LAND AT NORTH WEST BICESTER

TRANSPORT ASSESSMENT VOL 2 (ii) – APPENDIX E - J

STAGE 1 RSA DESIGNER'S RESPONSE

Stage 1 Road Safety Audit

DRAWING TITLE
POSSIBLE B4100/CHARLOTTE AVENUE TRAFFIC SIGNALS

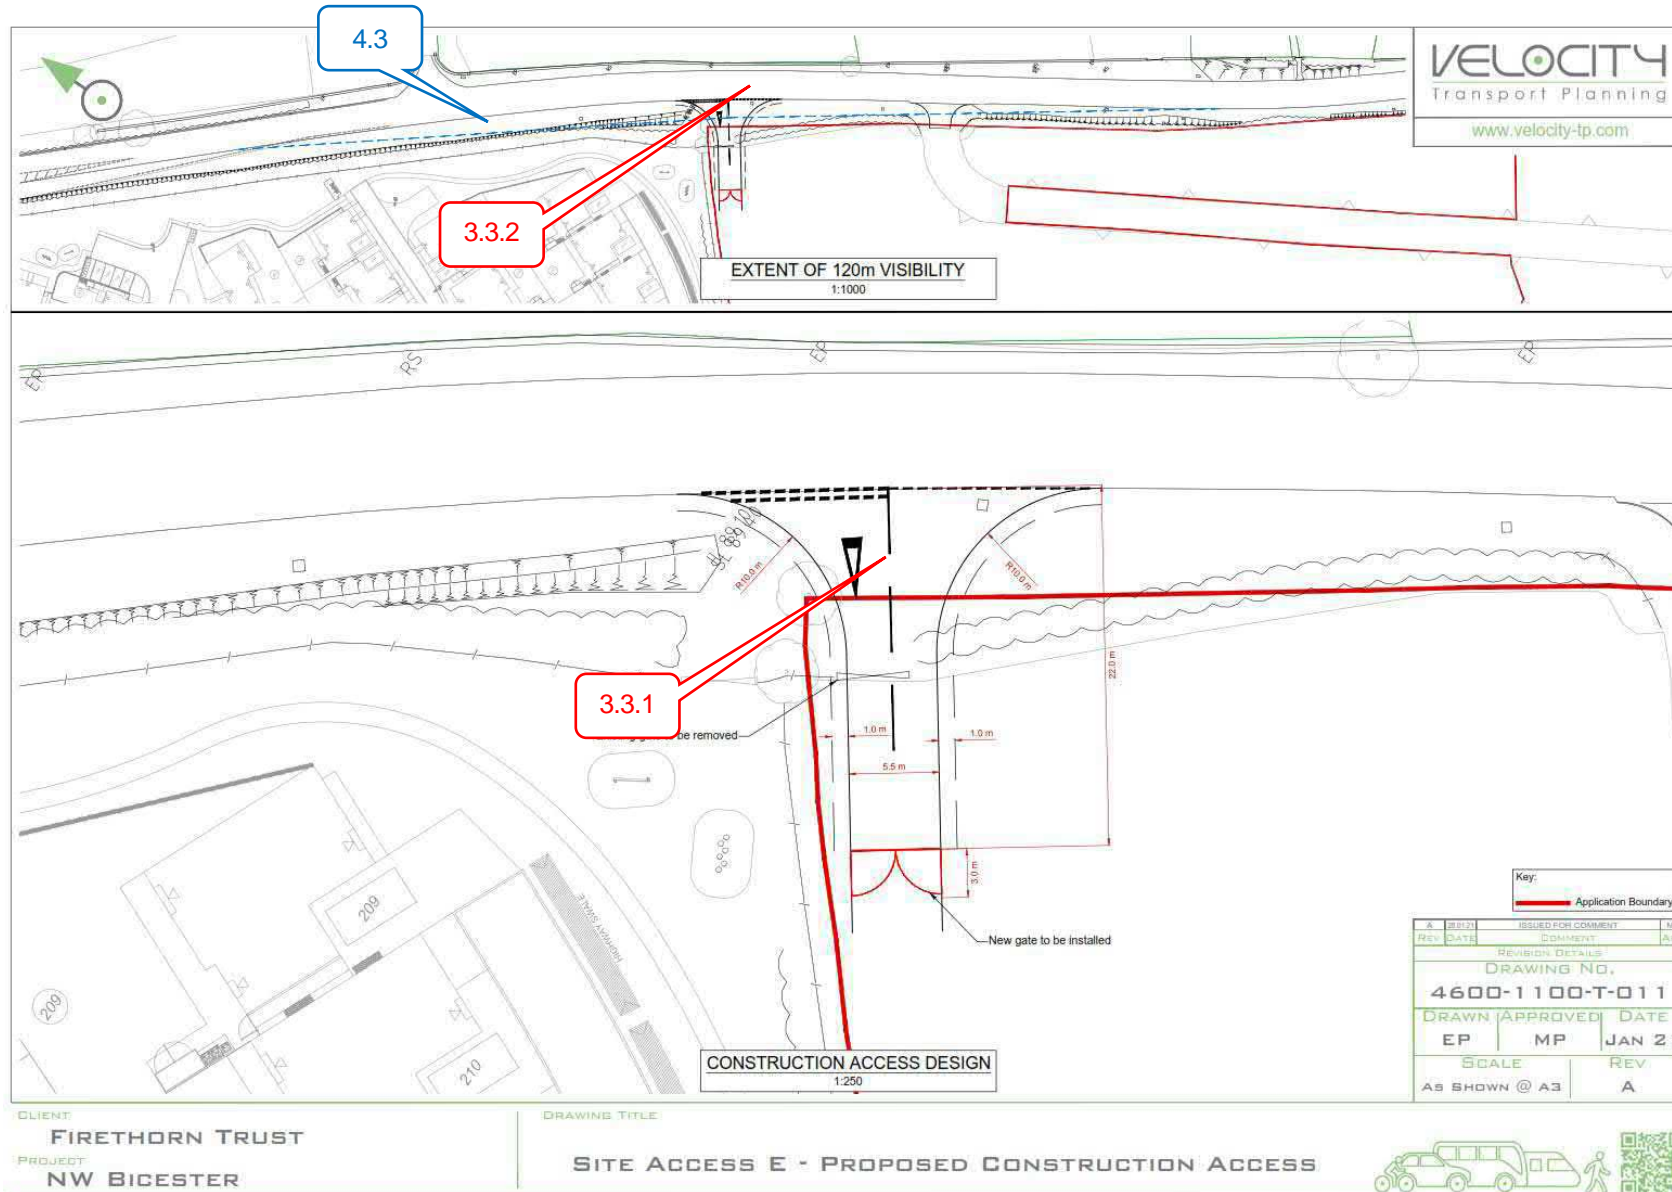
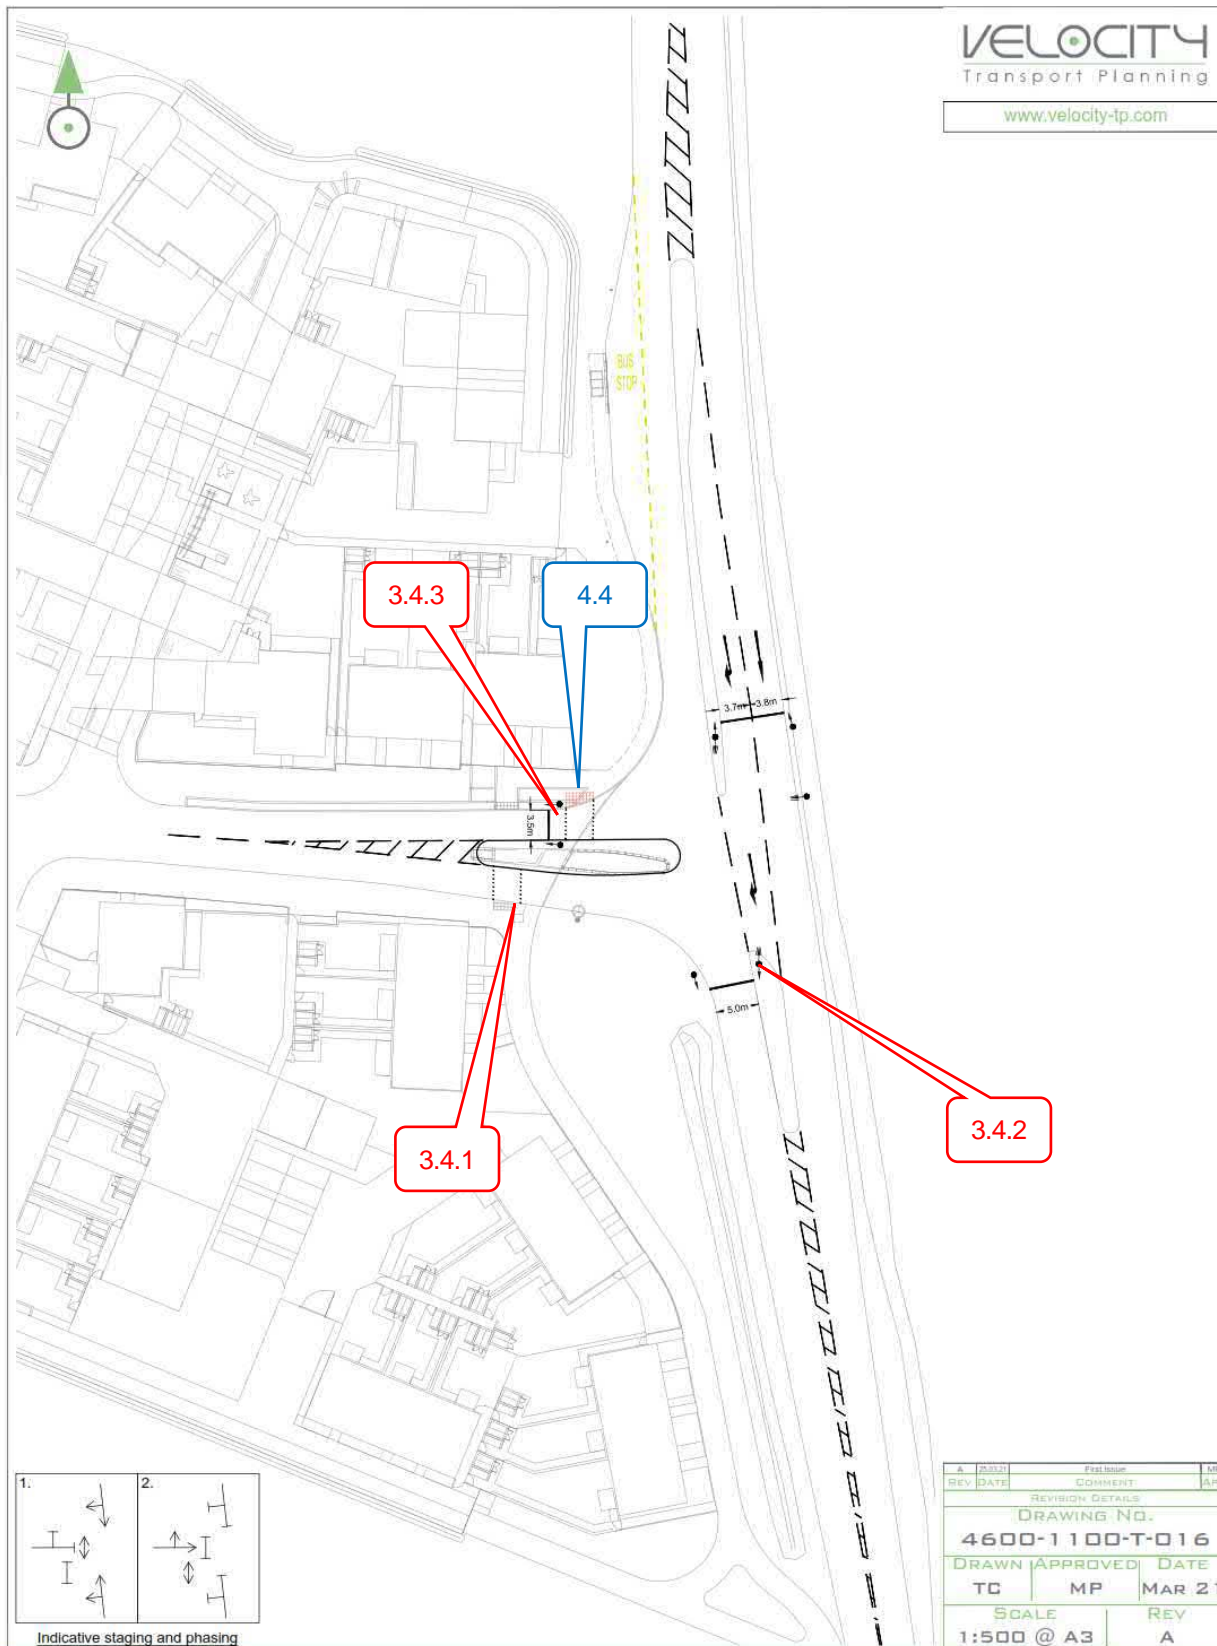
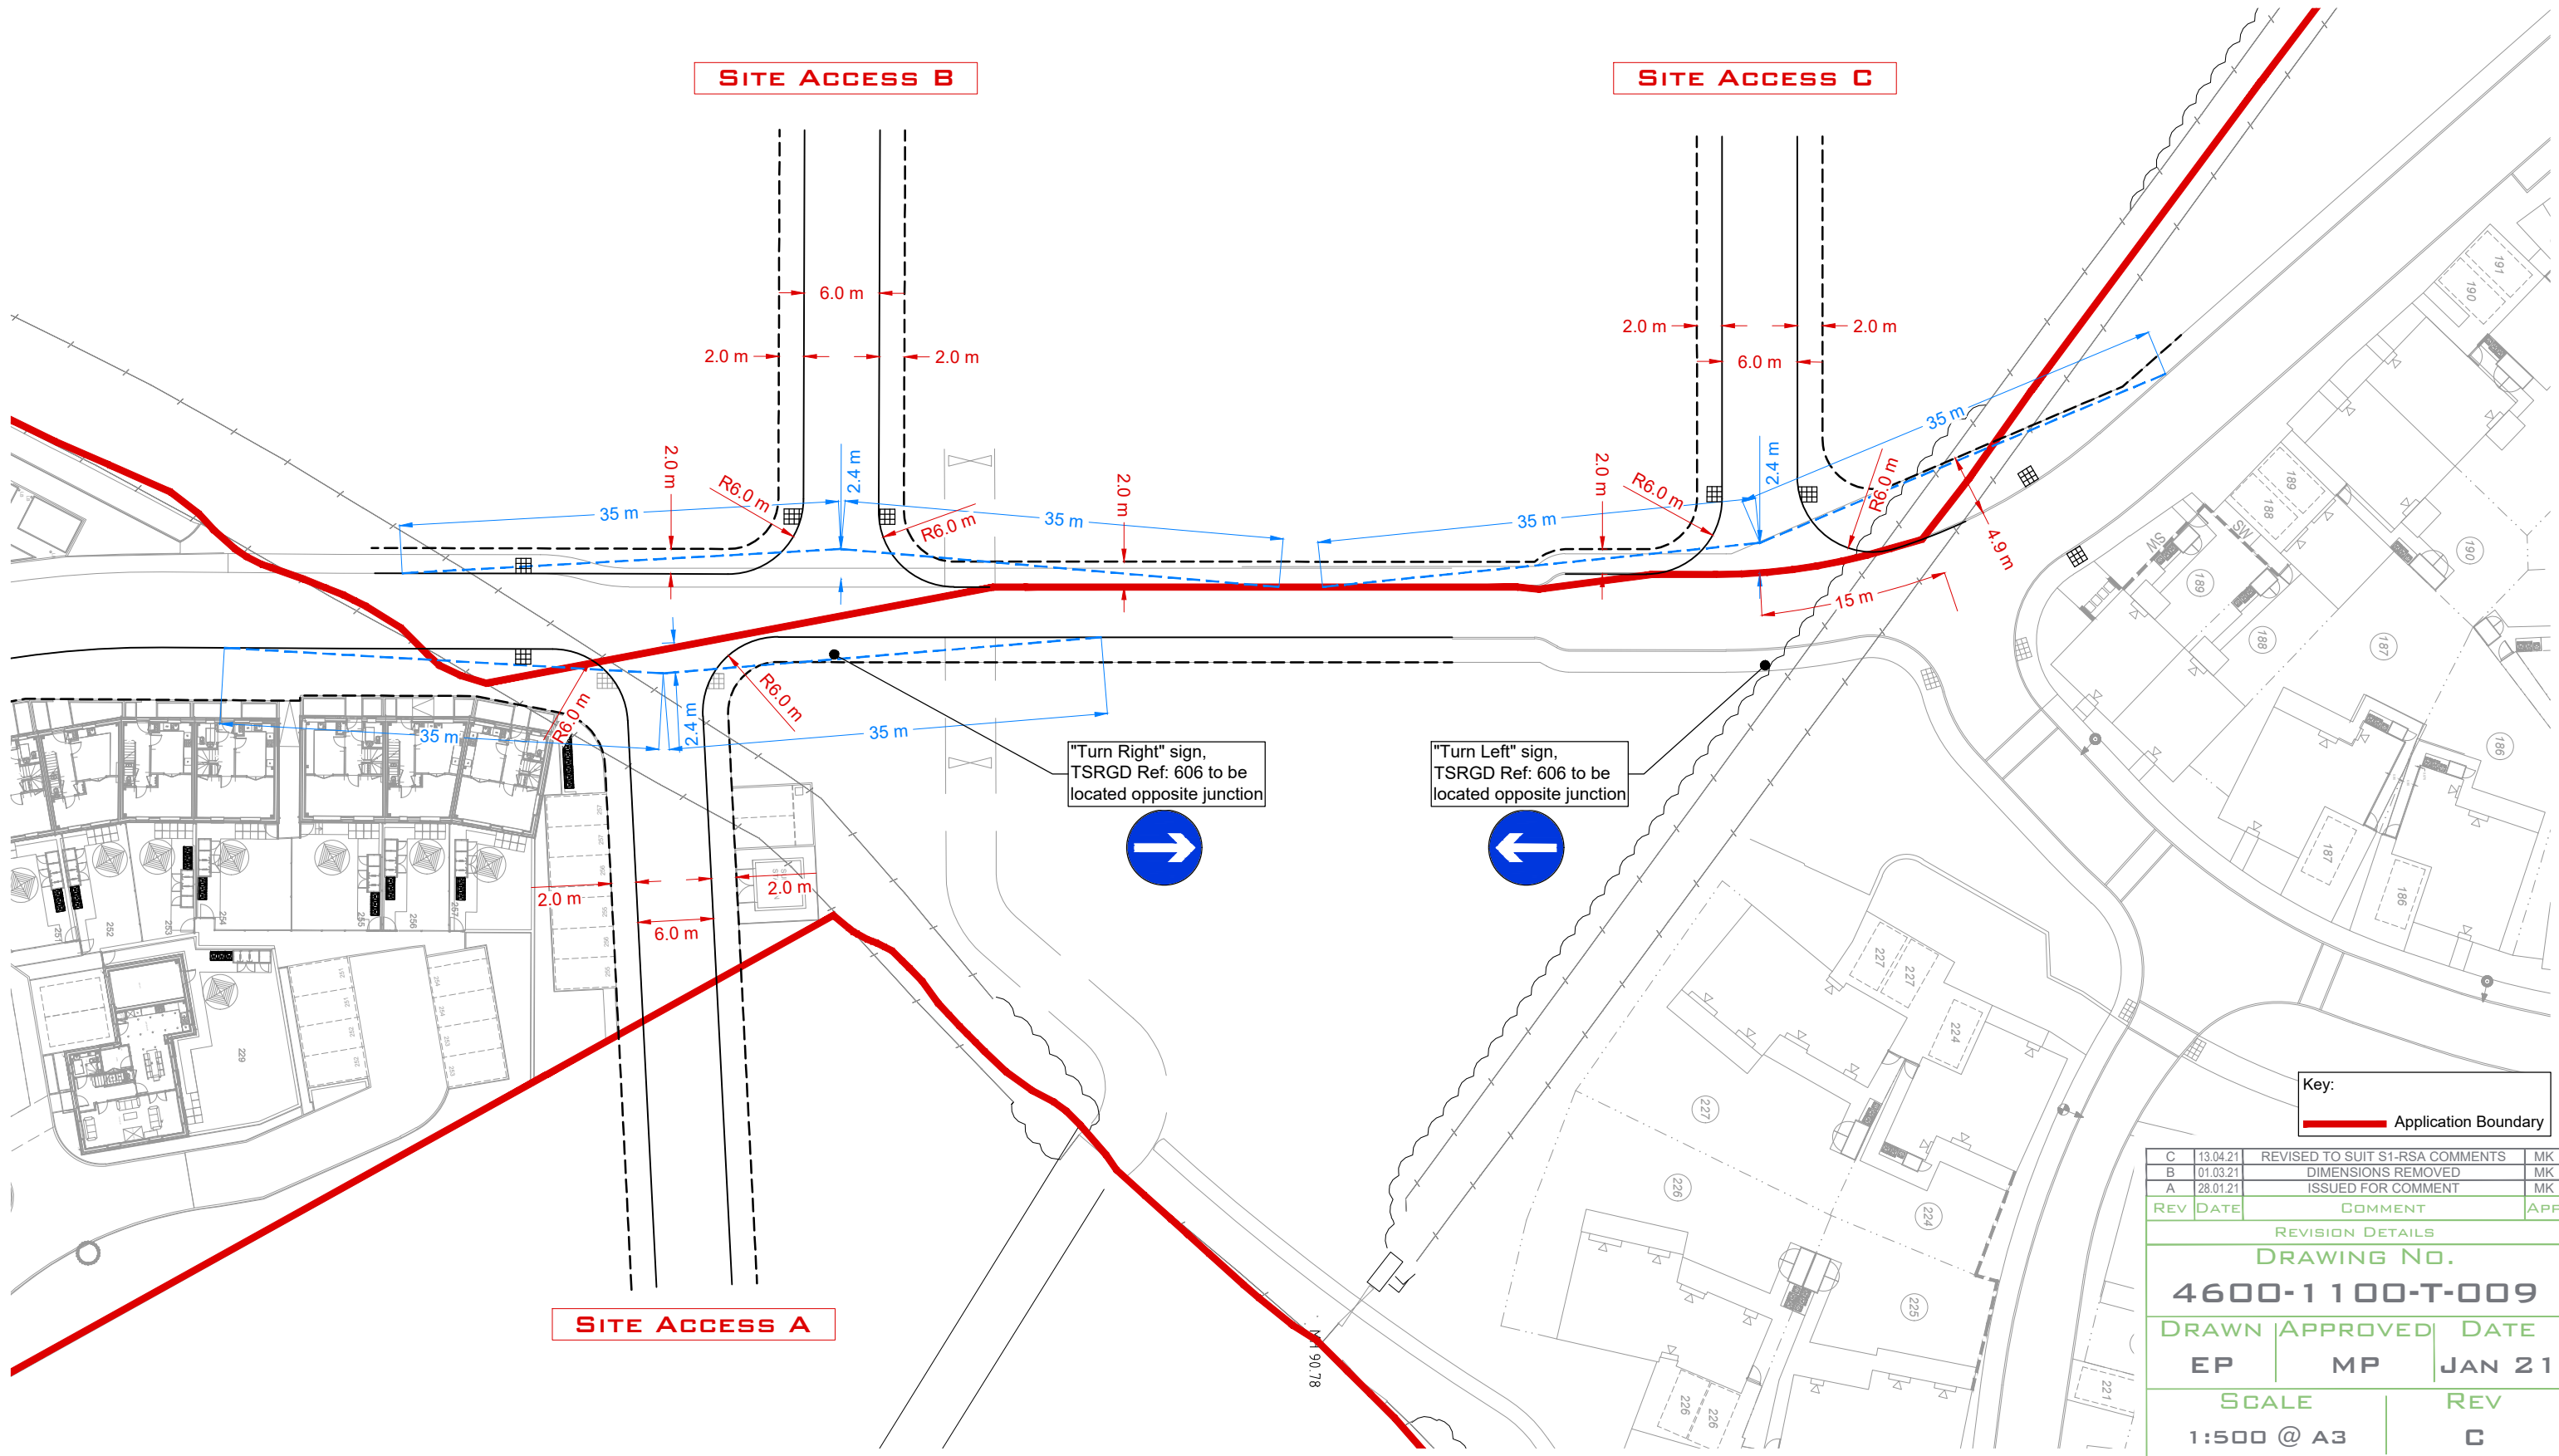
Summary: Pedestrian to vehicle collisions involving main road right turning vehicles

The staging layout on the drawing indicates that right turners turn within gaps in the opposing traffic or within the inter-green period.

The stacking space for waiting right turners may lead to up to four / five vehicles passing the signal stop line and attempting to clear the junction in the intergreen period. The intergreen period at the end of stage 1 may not be sufficient to clear the right turn queue leading to an increased risk of pedestrian to vehicle collisions at the crossing.

The staging layout on the drawing indicates that right turners turn within gaps in the opposing traffic or within the inter-green.

The junction layout on the drawing indicates a far sided secondary signal head for the southbound traffic stream. Drivers making the main road right turn manoeuvre may take their cue to commence a right turn based on this signal aspect. With the 40mph speed limit and observed high northbound speeds, northbound vehicles passing the stop line at the end of the stage may come into conflict with right turning vehicles.

The Linsig analysis shows no inter-green period between the termination of the traffic phase D to the start of pedestrian phase E and vice a versa. If insufficient time is provided between the termination of these phases, it may lead to a slow walking pedestrian being hit by a vehicle, leading to pedestrian injury.

It is recommended that appropriate inter-green periods are provided between the phases.

It is unclear from the information provided (as indicated by the tactile paving layout), whether the crossing on Charlotte Avenue will be installed as controlled crossing with traffic signal push button units and indicators) or as an uncontrolled crossing, although the phasing diagram appears to show the pedestrian movements as signal phases.

It is recommended the type of crossing should be clarified and at the detail design stage the colour and layout of the tactile paving should comply with latest guidance for the chosen crossing type.

3.4 – Charlotte Avenue Traffic Signal Controlled Junction (Drawing 4600-1100-T-016 Rev A)				
3.4.1	<p>Location: At the junction</p> <p>Summary: Pedestrian to vehicle collisions involving main road right turning vehicles</p> <p>The staging layout on the drawing indicates that right turners turn within gaps in the opposing traffic or within the inter-green period.</p> <p>The stacking space for waiting right turners may lead to up to four / five vehicles passing the signal stop line and attempting to clear the junction in the intergreen period. The intergreen period at the end of stage 1 may not be sufficient to clear the right turn queue leading to an increased risk of pedestrian to vehicle collisions at the crossing</p>	<p>It is recommended that the right turn manoeuvre is positively signalled, to minimise the possible pedestrian to vehicle conflict. Measures may include an early cut off with an indicative arrow and that an adequate inter-green period is provided to ensure queuing right turn vehicles can clear the crossing area before the pedestrian crossing signal is given a green person aspect.</p>	<p>The design of the traffic signal junction has been revisited to ensure that adequate time is afforded to the right turners to perform the manoeuvre. The results of this revised signal arrangement are set out within the supporting Transport Assessment.</p>

3.4.2	<p>Location: At the junction</p> <p>Summary: Collisions involving main road right turning vehicles</p> <p>The staging layout on the drawing indicates that right turners turn within gaps in the opposing traffic or within the inter-green.</p> <p>The junction layout on the drawing indicates a far sided secondary signal head for the southbound traffic stream. Drivers making the main road right turn manoeuvre may take their cue to commence a right turn based on this signal aspect. With the 40mph speed limit and observed high northbound speeds, northbound vehicles passing the stop line at the end of the stage may come into conflict with right turning vehicles</p>	<p>It is recommended that the right turn manoeuvre is positively signalled, to minimise the possible right turn across path conflict. Measures may include an early cut off with an indicative arrow or if the staging arrangement is to remain as a two stage, the far sided signal aspect should be relocated to be closely associated.</p>	<p>See comment above.</p>

3.4.3	<p>Location: At the junction</p> <p>Summary: Pedestrian to vehicle collisions leading to pedestrian injury</p> <p>The Linsig analysis shows no inter-green period between the termination of the traffic phase D to the start of pedestrian phase E and vice a versa. If insufficient time is provided between the termination of these phases, it may lead to a slow walking pedestrian being hit by a vehicle, leading to pedestrian injury</p>	It is recommended that appropriate inter-green periods are provided between the phases	See comment above.

4.4	<p>Location: Charlotte Avenue Traffic Signal Junction</p> <p>It is unclear from the information provided (as indicated by the tactile paving layout), whether the crossing on Charlotte Avenue will be installed as controlled crossing with traffic signal push button units and indicators, or as an uncontrolled crossing, although the phasing diagram appears to show the pedestrian movements as signal phases.</p> <p>It is recommended the type of crossing should be clarified and at the detail design stage the colour and layout of the tactile paving should comply with latest guidance for the chosen crossing type</p>		<p>The proposed signal junction arrangement as presented within the TA includes signalised pedestrian crossing phases. The colour and layout of the tactile paving will be finalised at the detailed design stage.</p>	
-----	---	--	--	--
